Talavera Floodplain Delineation Study Technical Review

Noah's Ark Group Study
Las Cruces, New Mexico
September 17, 2008

Hydrology: Subbasin Delineation

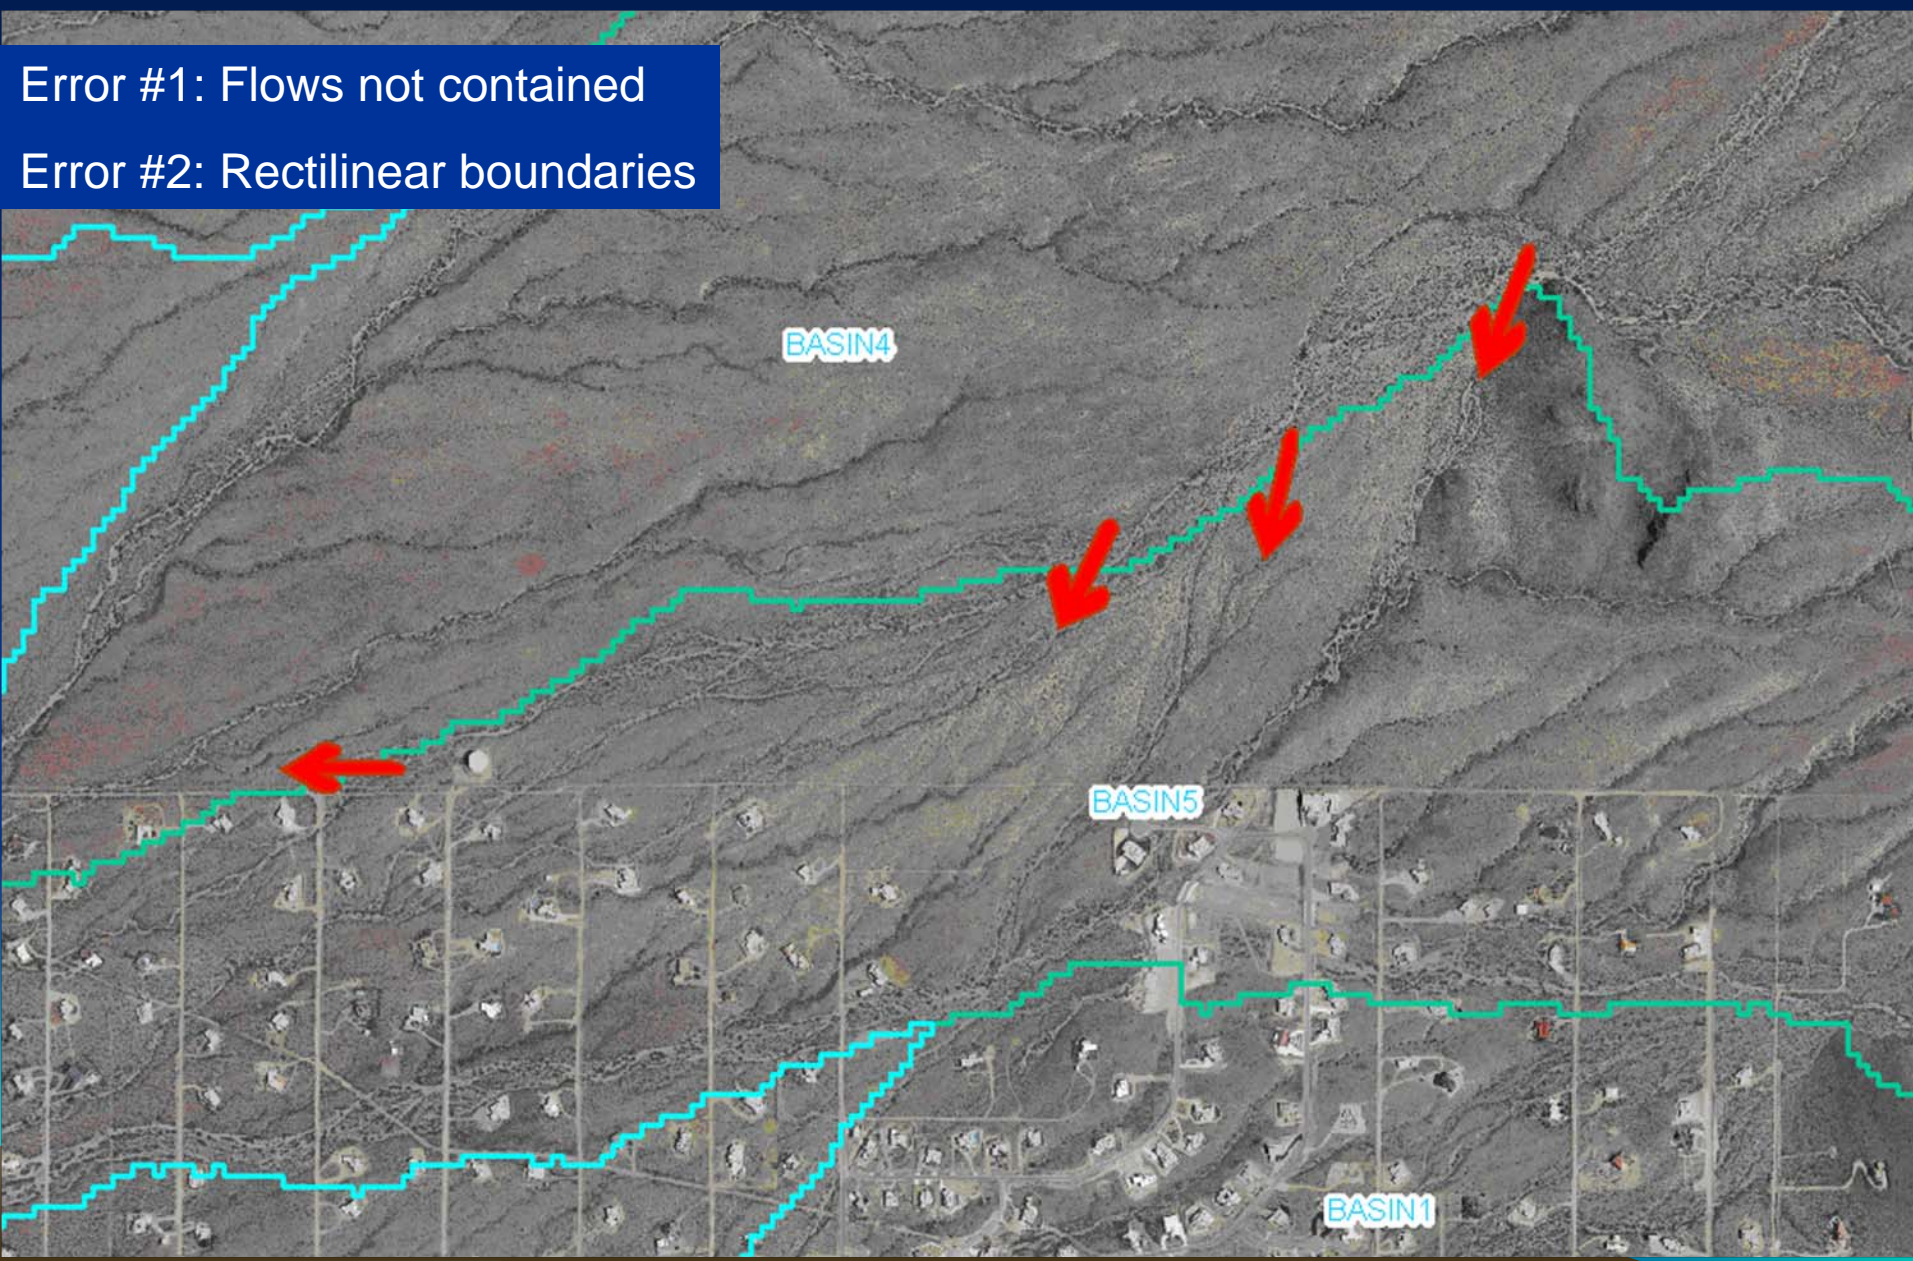
Error #1: Irregular shapes
Error #2: Irregular sizes
Error #3: Multiple outlets

Watershed Hydrograph Comparison for Fillmore Arroyo

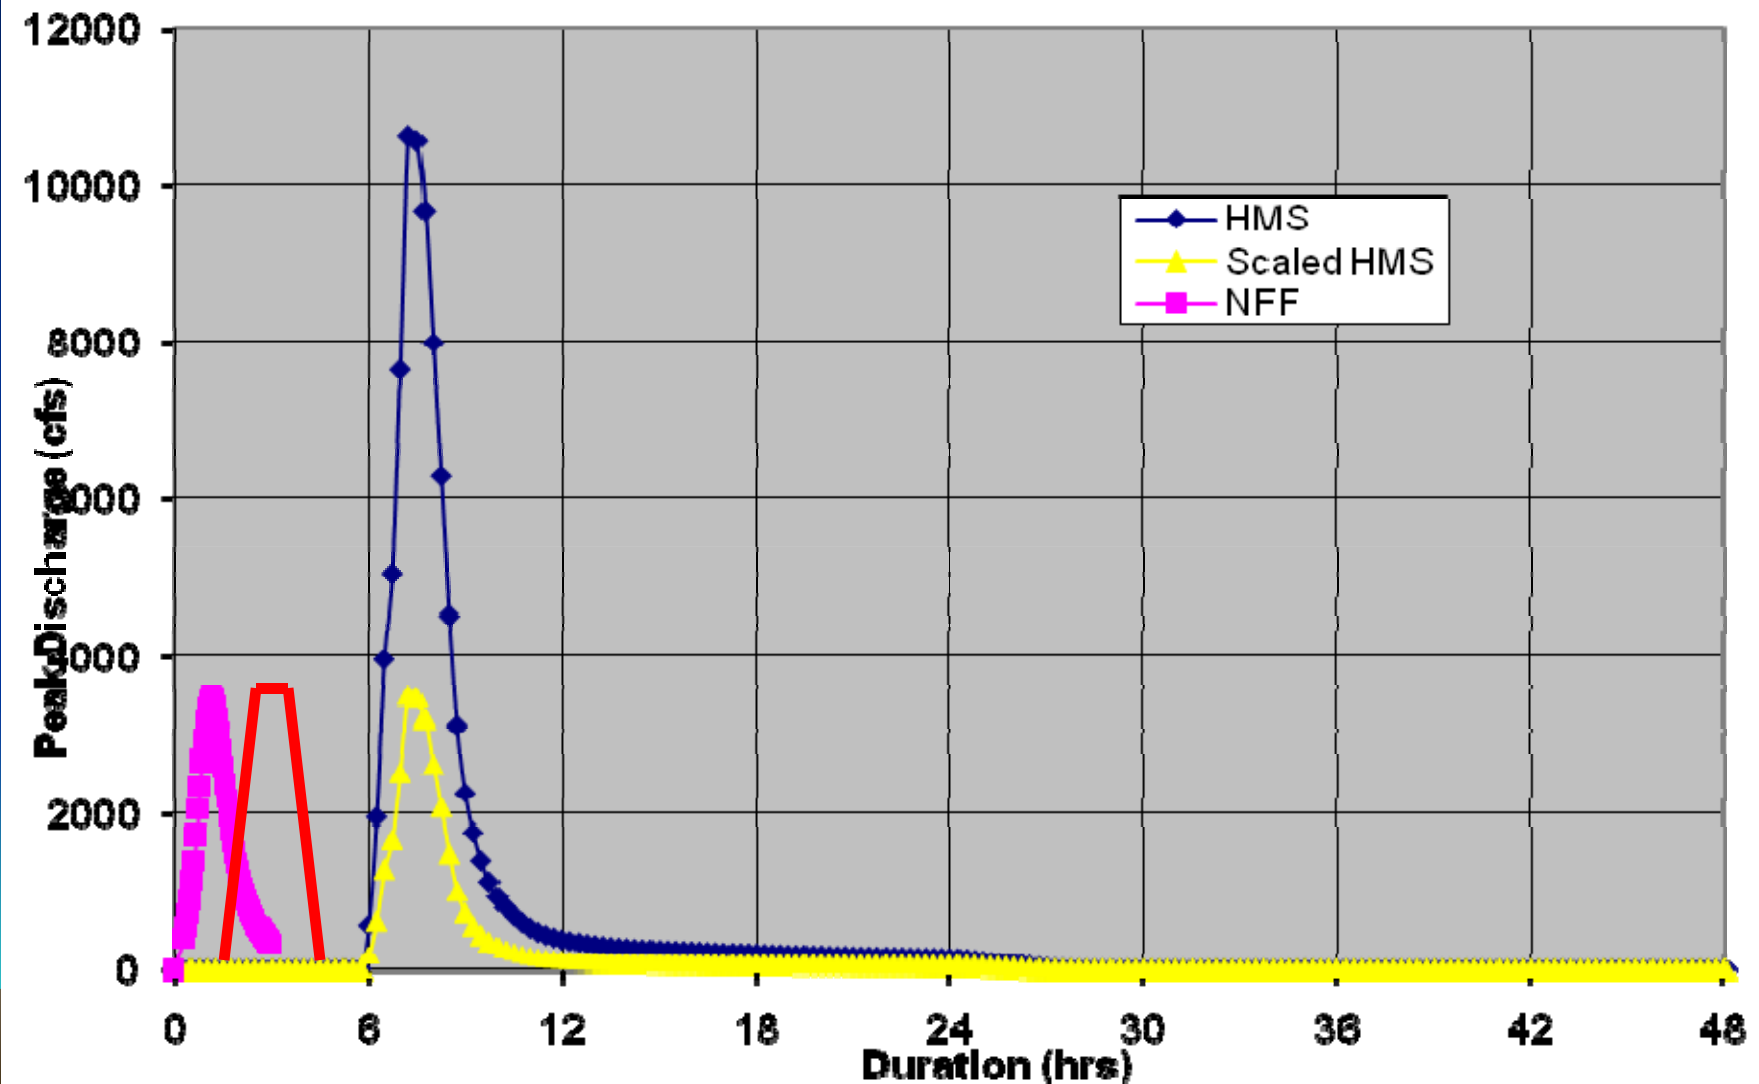
- Subbasin Delineation
 - Boundaries
 - Shape
 - Size
- Hydrograph
 - Regression Equation => Peak Only
 - Hydrograph Used vs. Modeled
- Discharge Inflow Points
